GENERAL ELECTRIC
729 E 729
TITLE ARRANGEMENT
REACTOR WELL SEAL
FITZPATRICK NUCLEAR PLANT
MPL 1-8
PO 205-
FCF 216X864B(STANDARD PLANT 218T560)1-8
FCF 236X350B
A71-2020
NOTES:

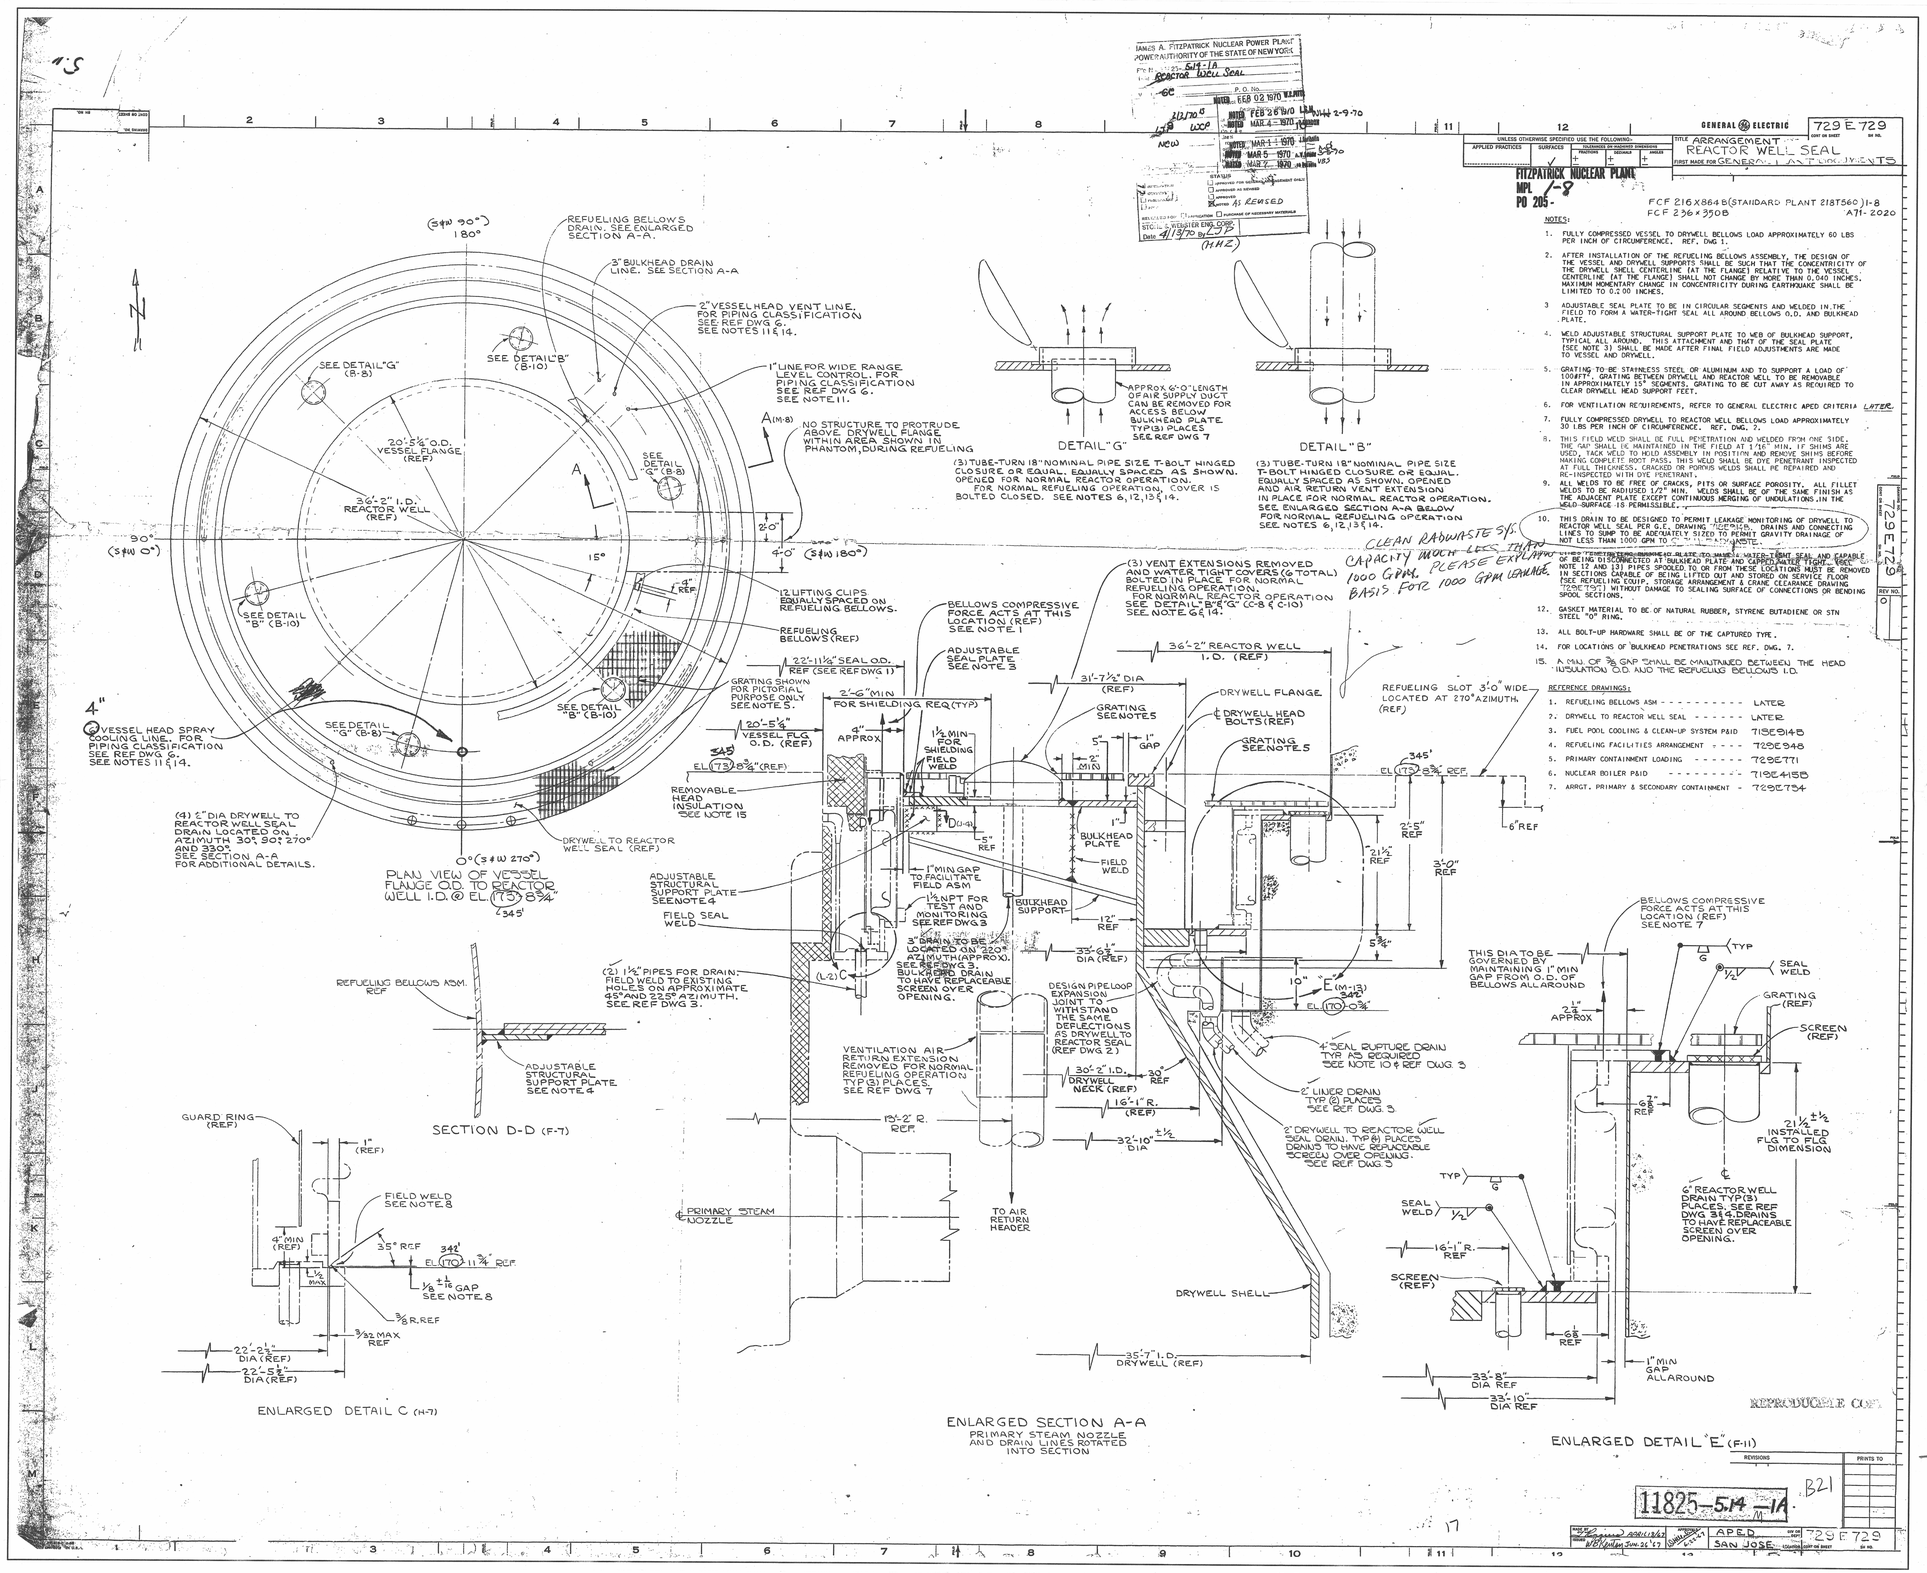
10. THIS DRAIN TO BE DESIGNED TO PERMIT LEAKAGE MONITORING OF DRYWELL TO REACTOR WELL SEAL PER G.E. DRAWING 729E618. DRAINS AND CONNECTING LINES TO SUMP TO BE ADEQUATELY SIZED TO PERMIT GRAVITY DRAINAGE OF NOT LESS THAN 1000 GPM TO [illegible] WASTE.
CLEAN RADWASTE S/S
CAPACITY MUCH LESS THAN 1000 GPM. PLEASE EXPLAIN
1000 GPM BASIS FOR 1000 GPM LEAKAGE
